PRELIMINARY PLAT
THE VILLAGES AT MAGNOLIA LANE PHASE 2-3

A SUBDIVISION IN THE CITY OF BRYANT, SALINE COUNTY, ARKANSAS

DATE:	01/11/2021	C.A.D. BY: B.JOHNSON	DRAWING NUMBER:
REVISED:	11/21/2023	CHECKED BY:	19-0238
		SCALE: 1"=100'

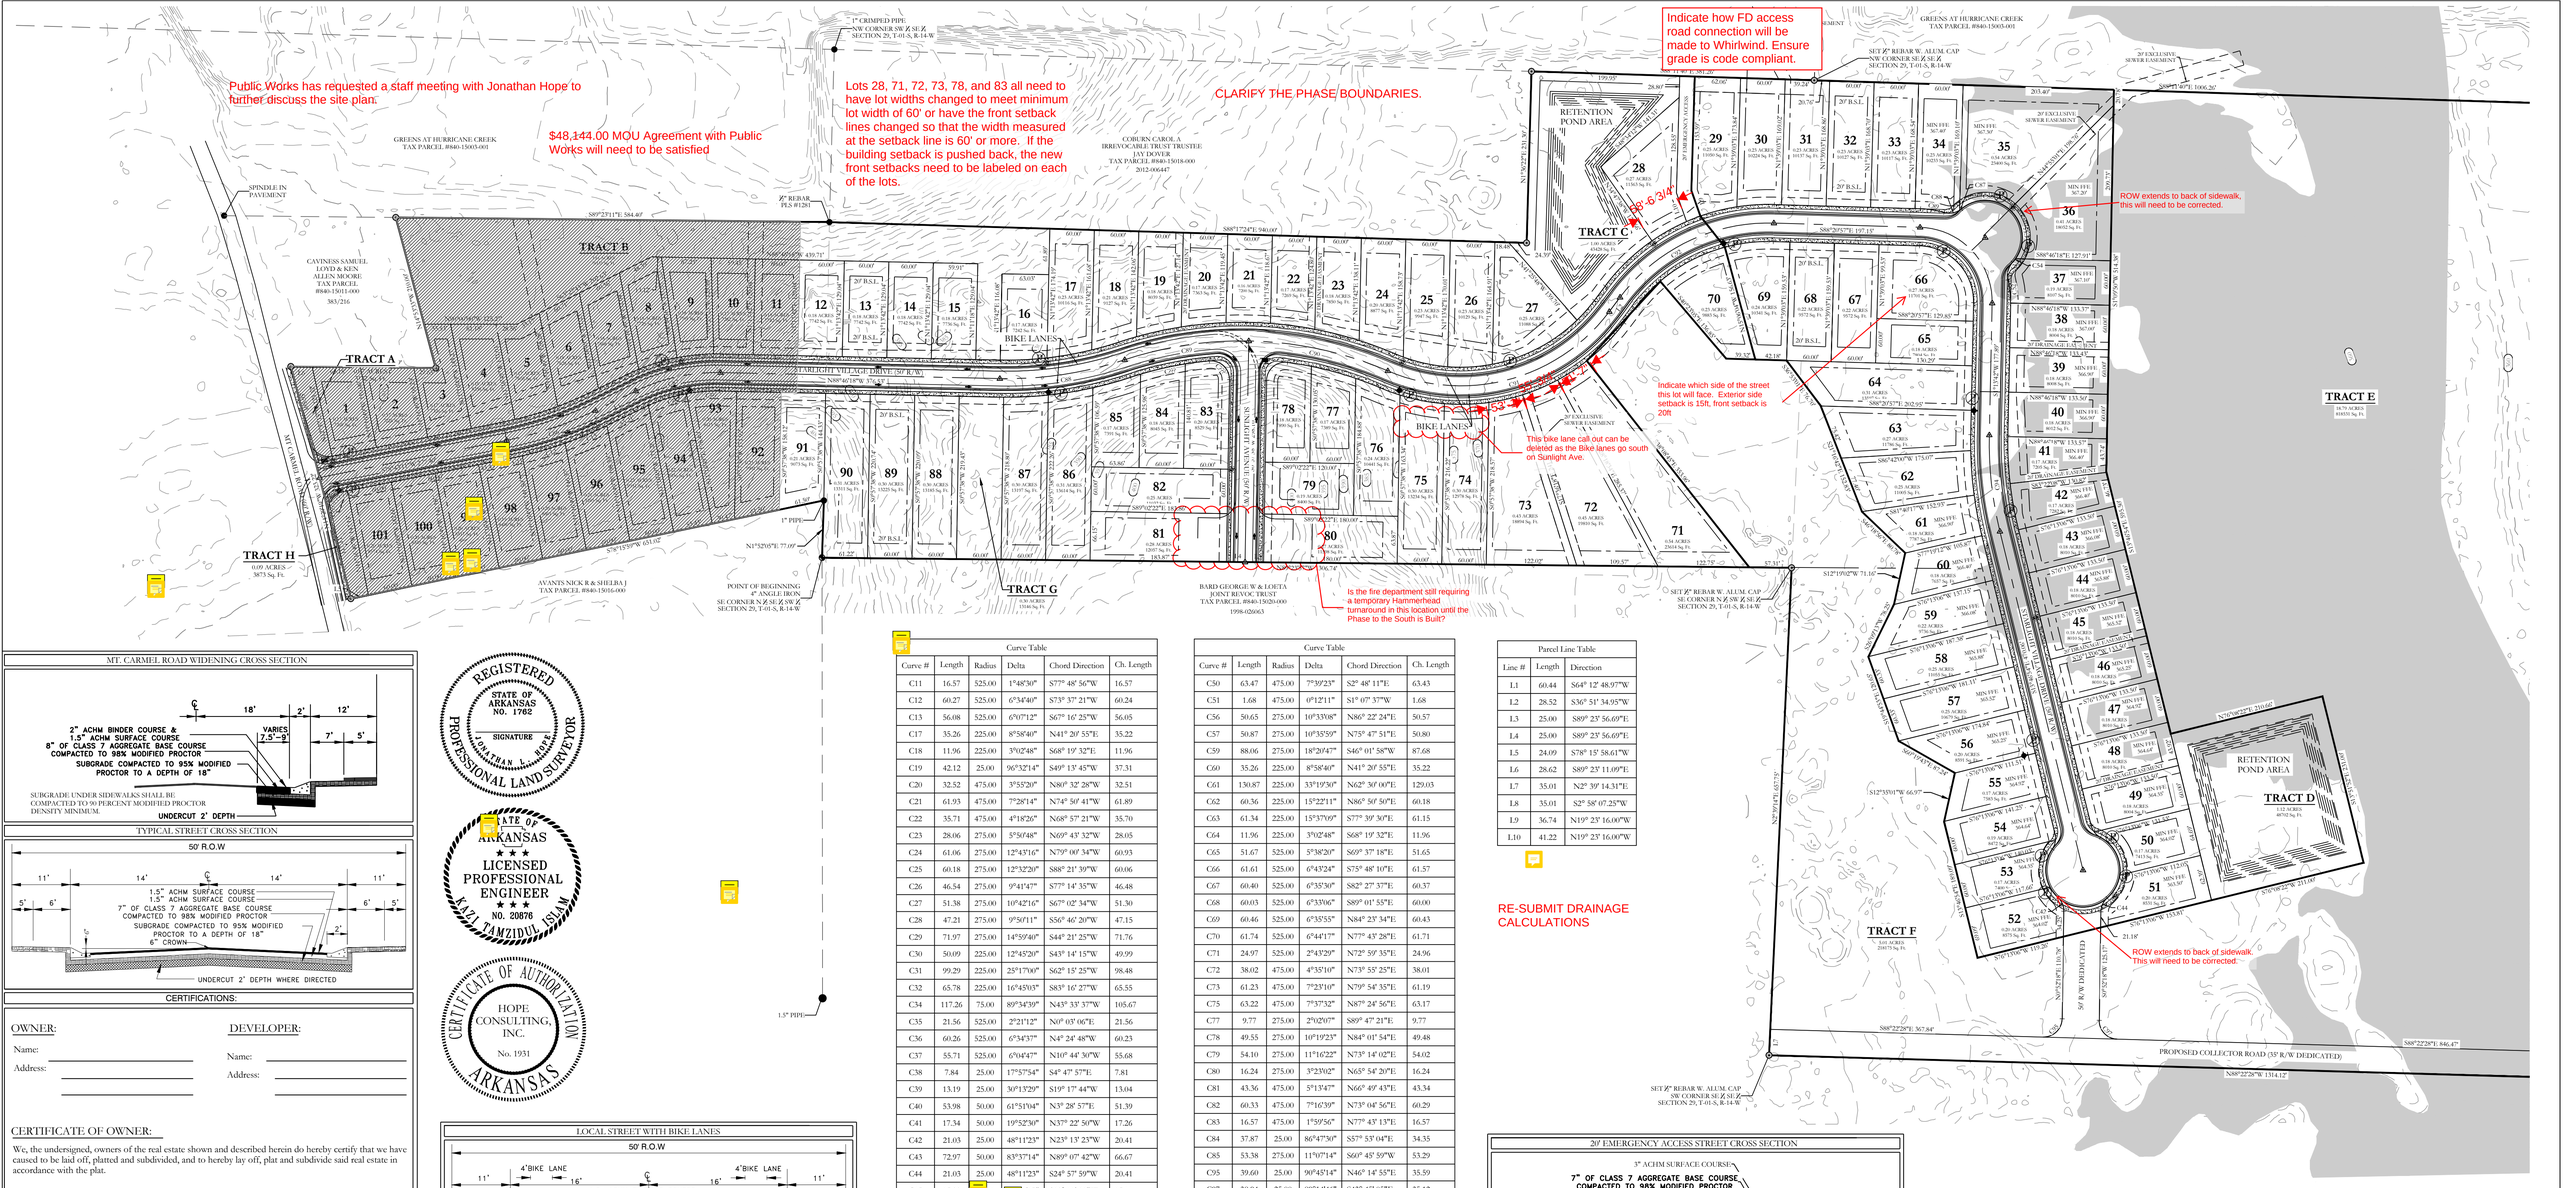
Public Works has requested a staff meeting with Jonathan Hope to further discuss the site plan.

$48,144.00 MOU Agreement with Public Works will need to be satisfied

Lots 28, 71, 72, 73, 78, and 83 all need to have lot widths changed to meet minimum lot width of 60' or have the front setback lines changed so that the width measured at the setback line is 60' or more. If the building setback is pushed back, the new front setbacks need to be labeled on each of the lots.

CLARIFY THE PHASE BOUNDARIES.

Indicate how FD access road connection will be made to Whirlwind. Ensure grade is code compliant.

RE-SUBMIT DRAINAGE CALCULATIONS

THE VILLAGES AT MAGNOLIA LANE PHASE 2-3 STREET PLAN AND PROFILES

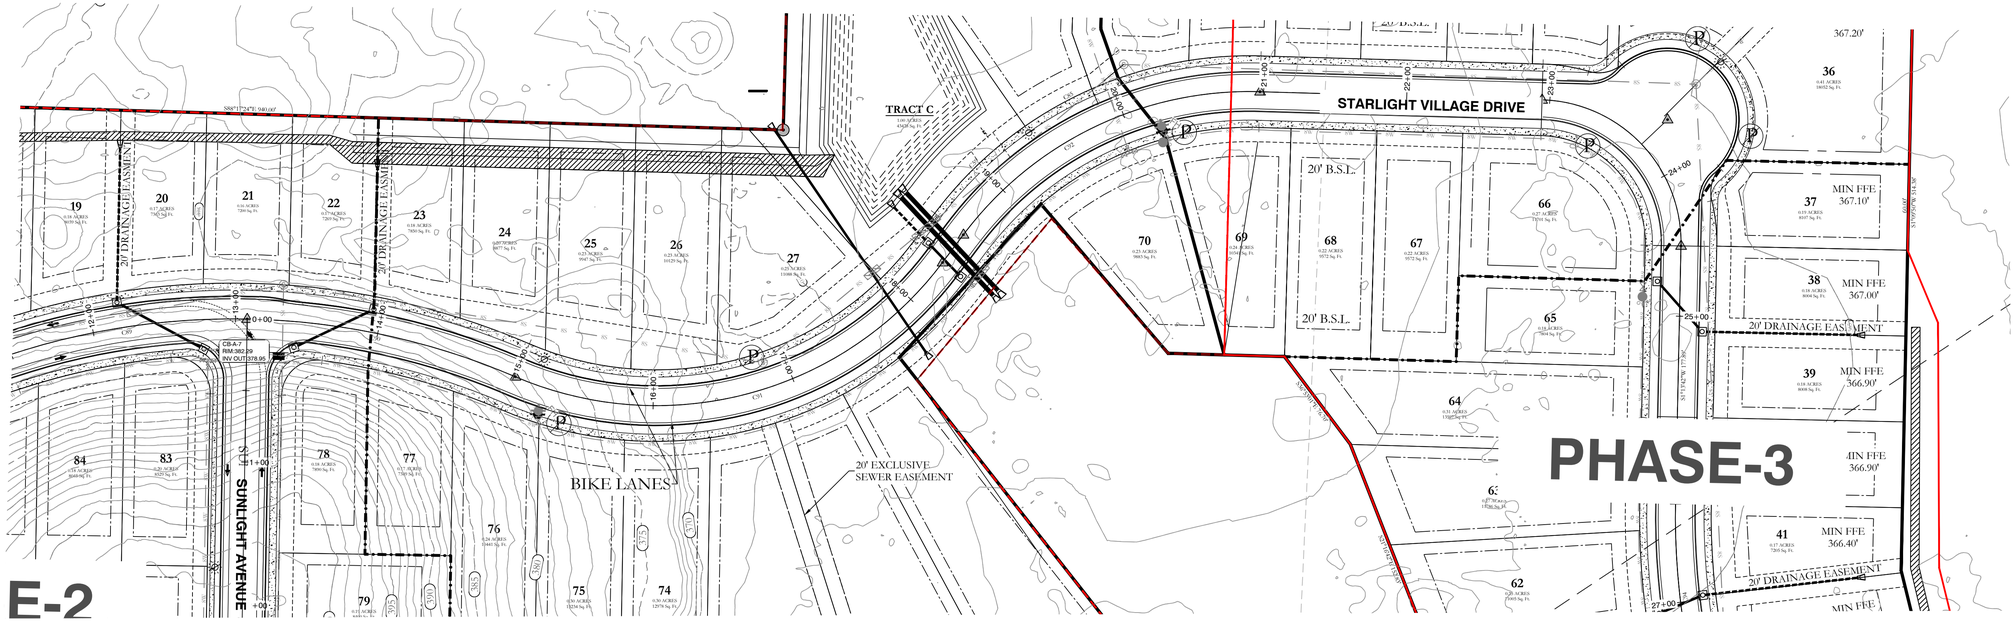
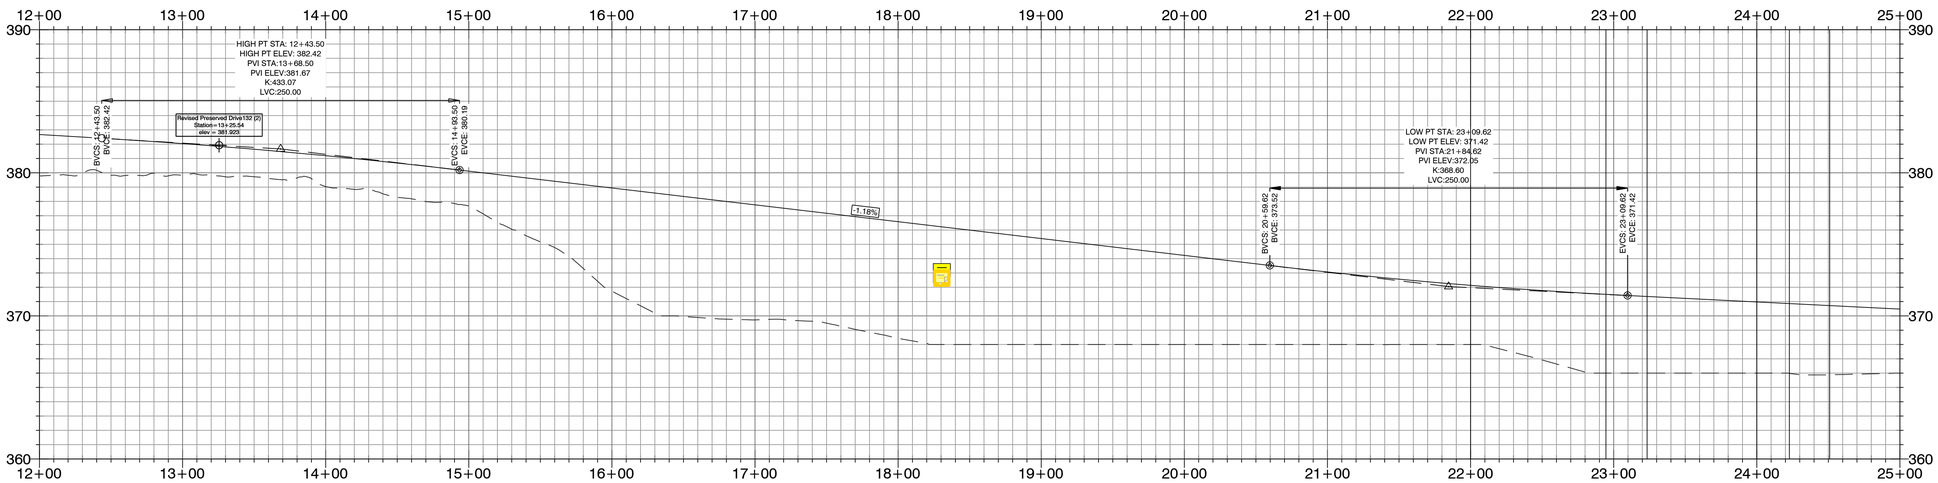
WHERE IS THE CENTERLINE DATA?

SEE ALL THE NOTES ON THE FIRST TWO SHEETS

DESIGN SPEED?

THE VILLAGES AT MAGNOLIA LANE PHASE 2-3
STREET PLAN AND PROFILE
A SUBDIVISION IN CITY OF BRYANT, SALINE COUNTY, ARKANSAS

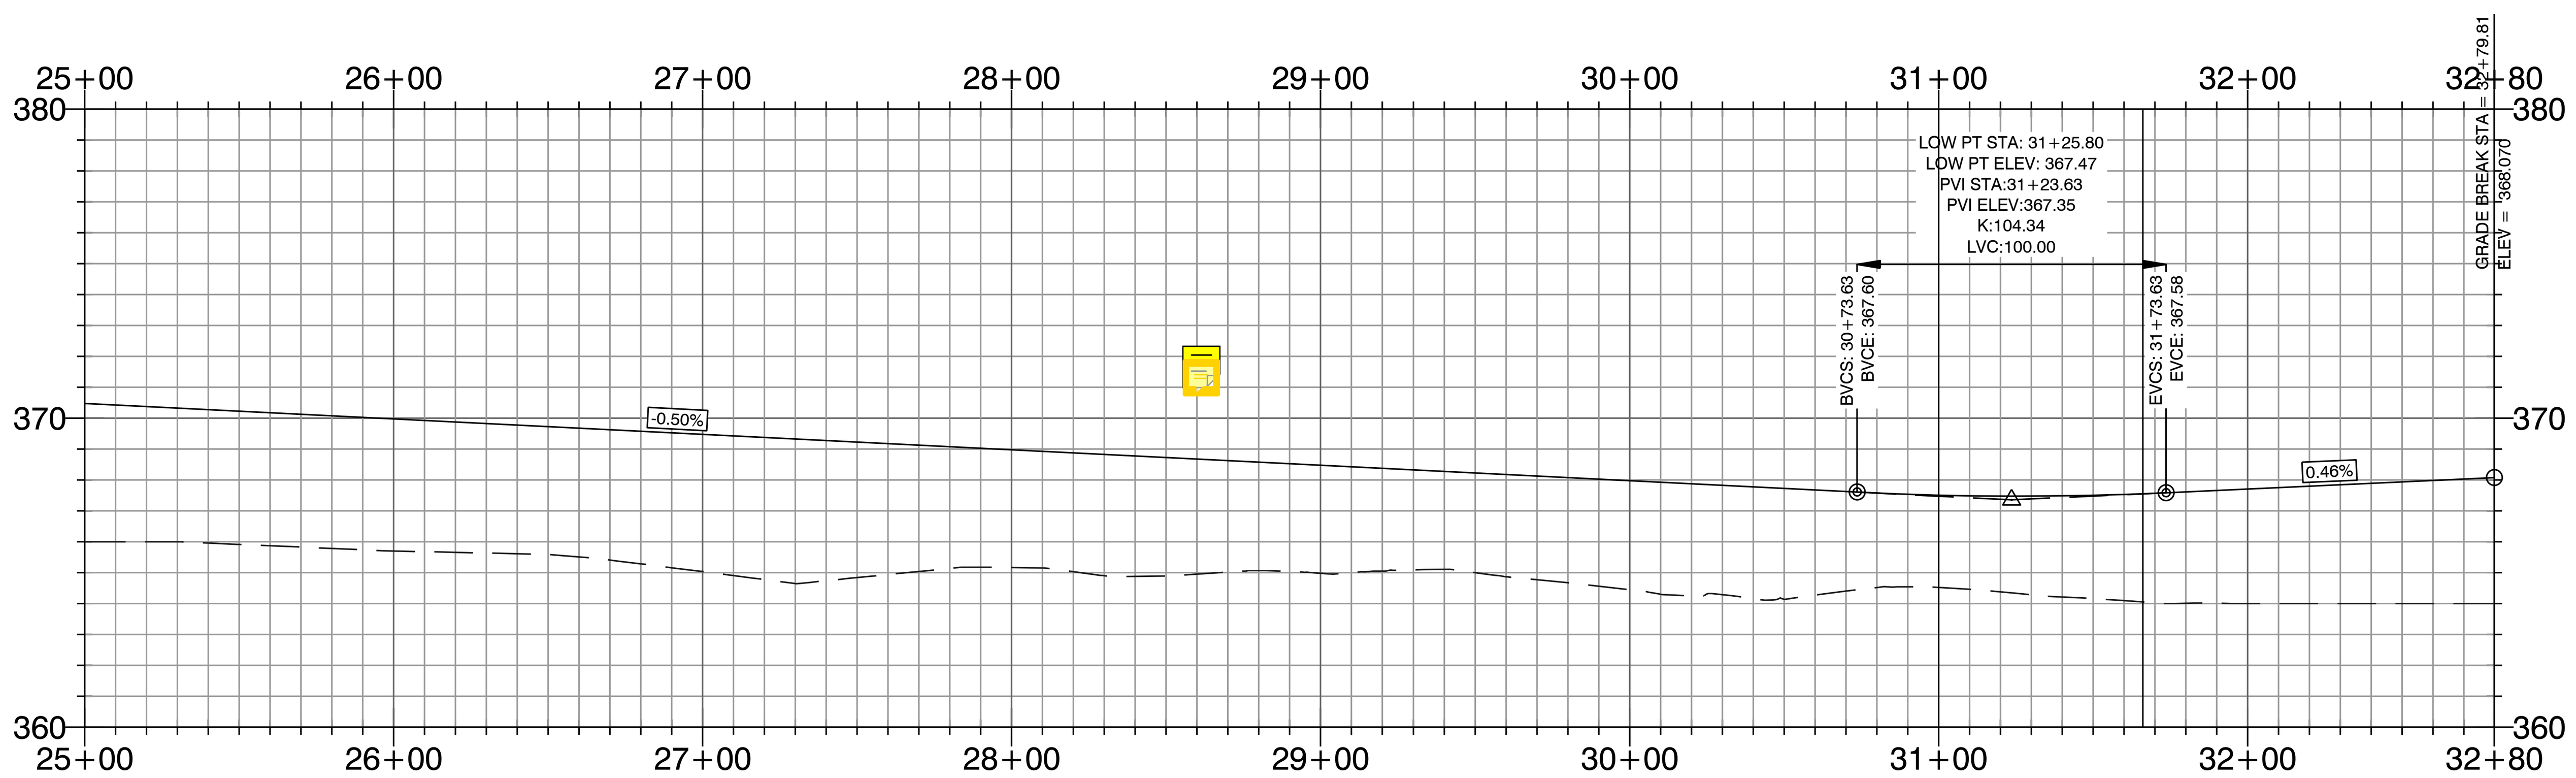
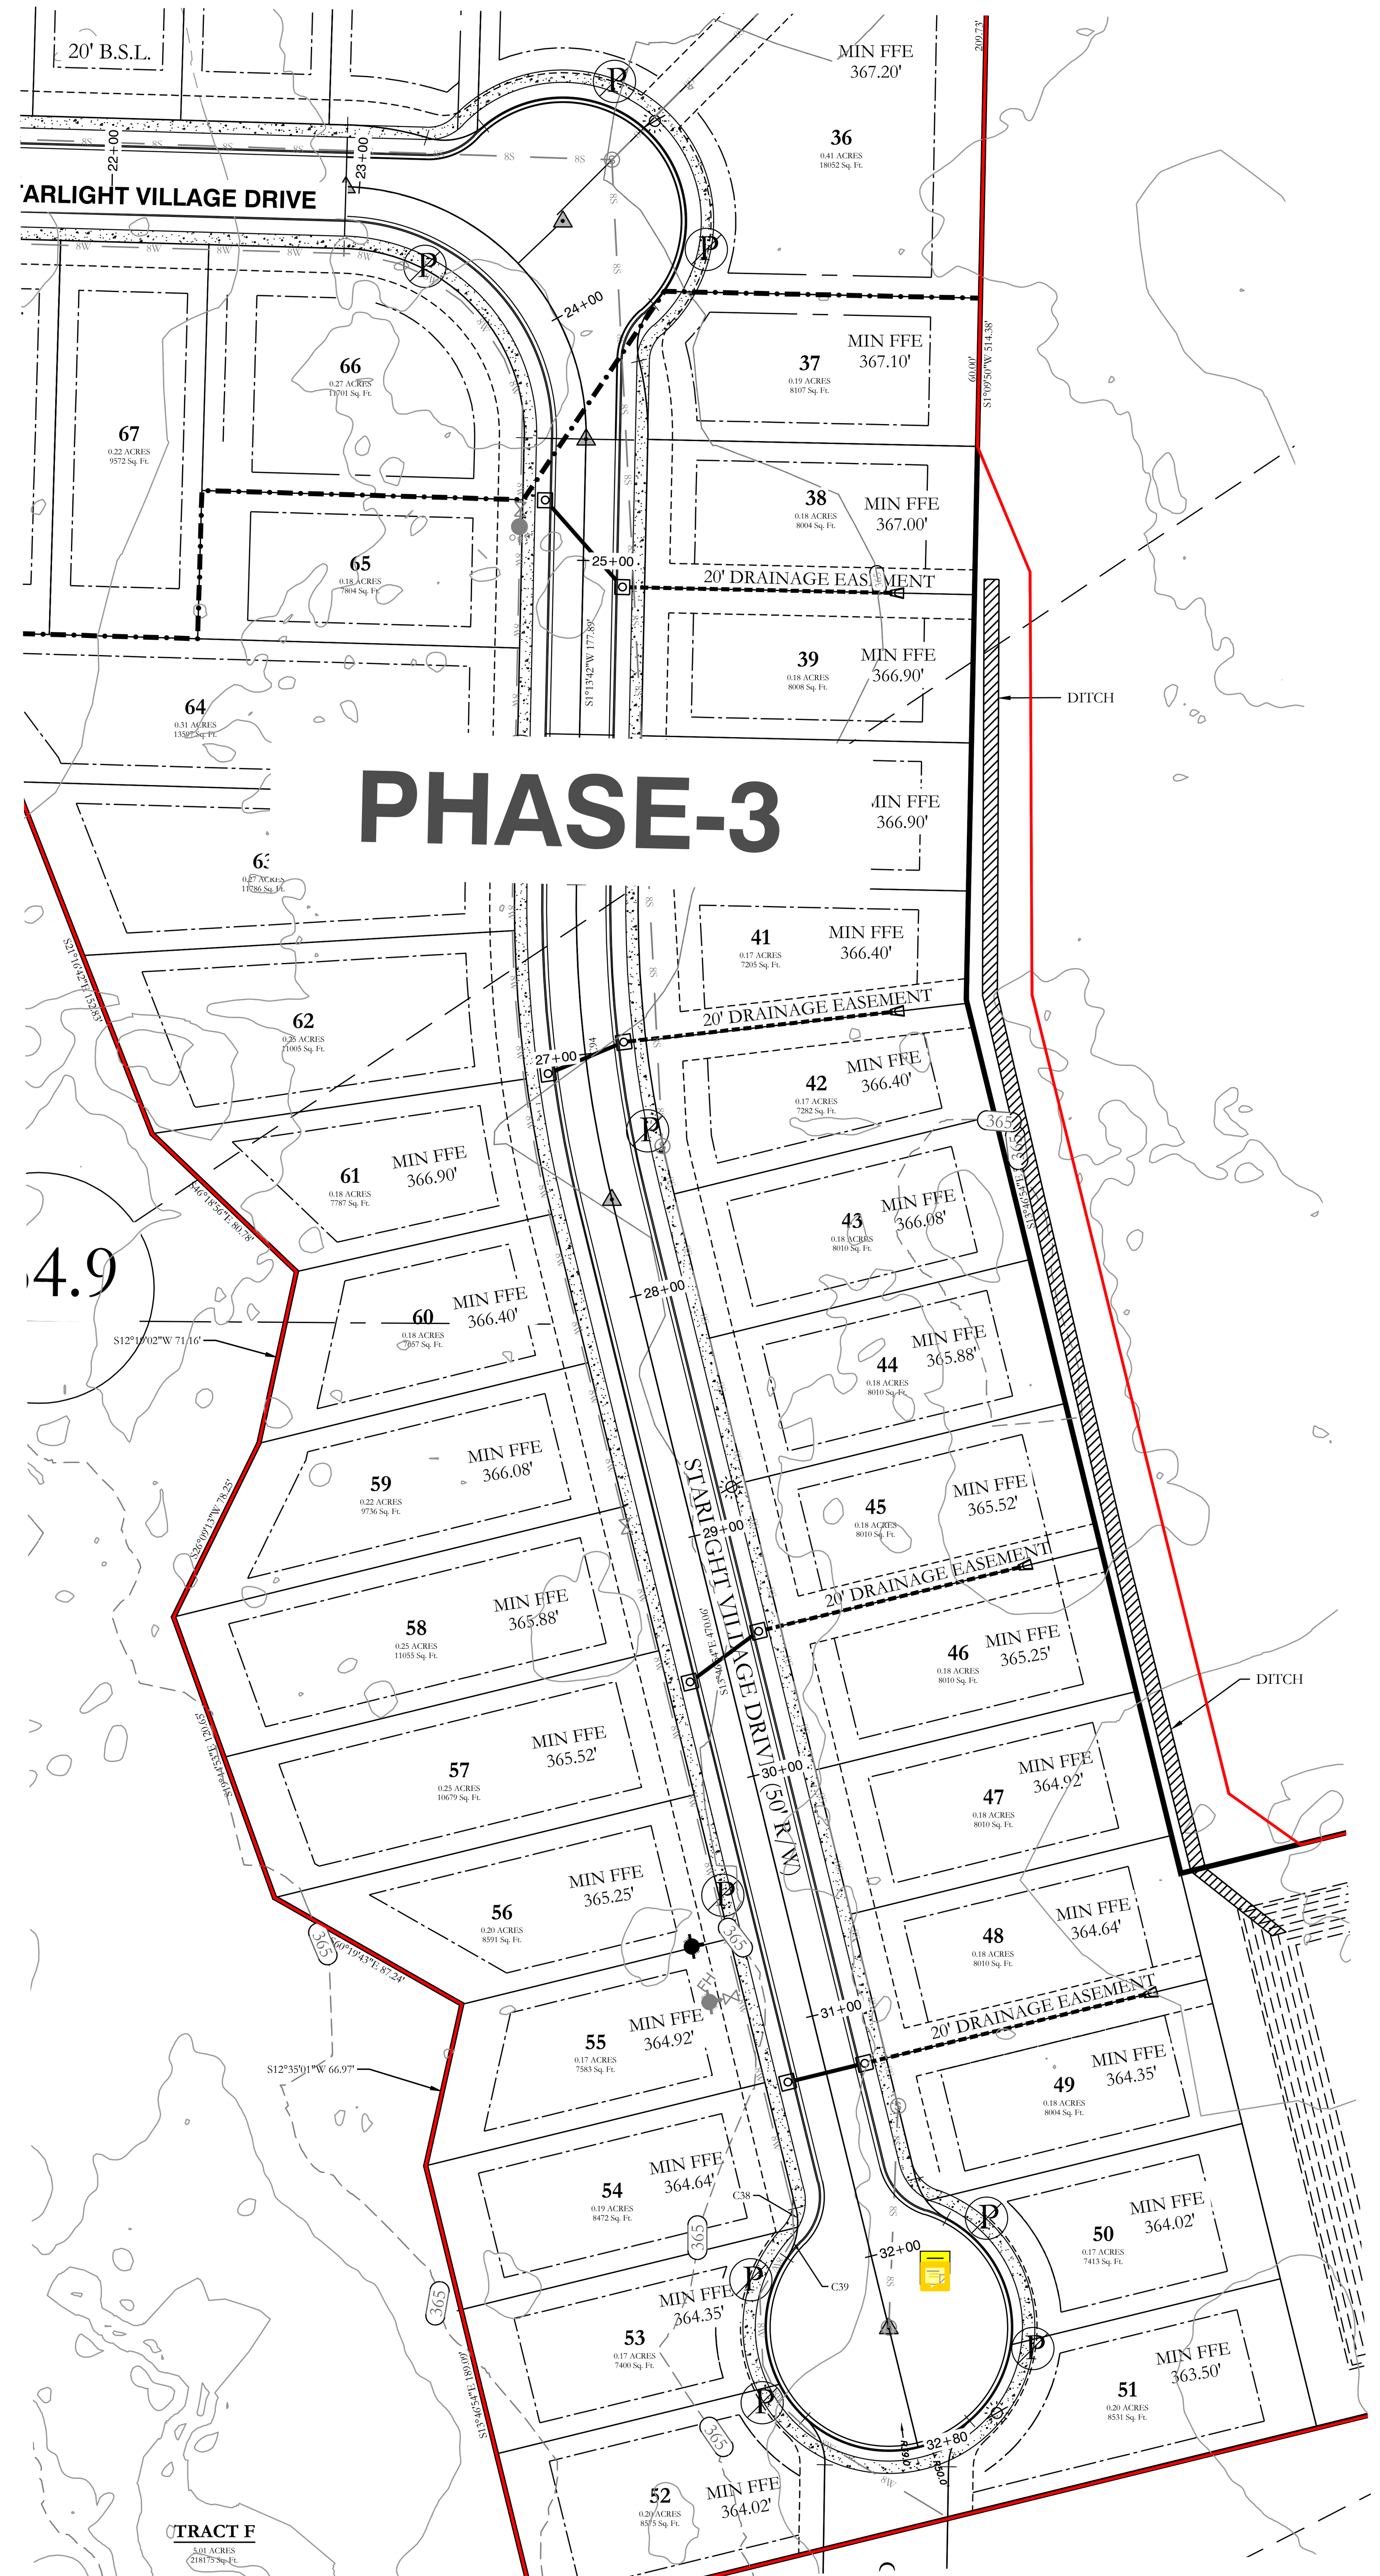
WHERE IS THE CENTERLINE DATA?

SEE ALL THE NOTES ON THE FIRST TWO SHEETS

DESIGN SPEED?

SHOW 100-YEAR FLOOD ELEVATION ON PROFILE
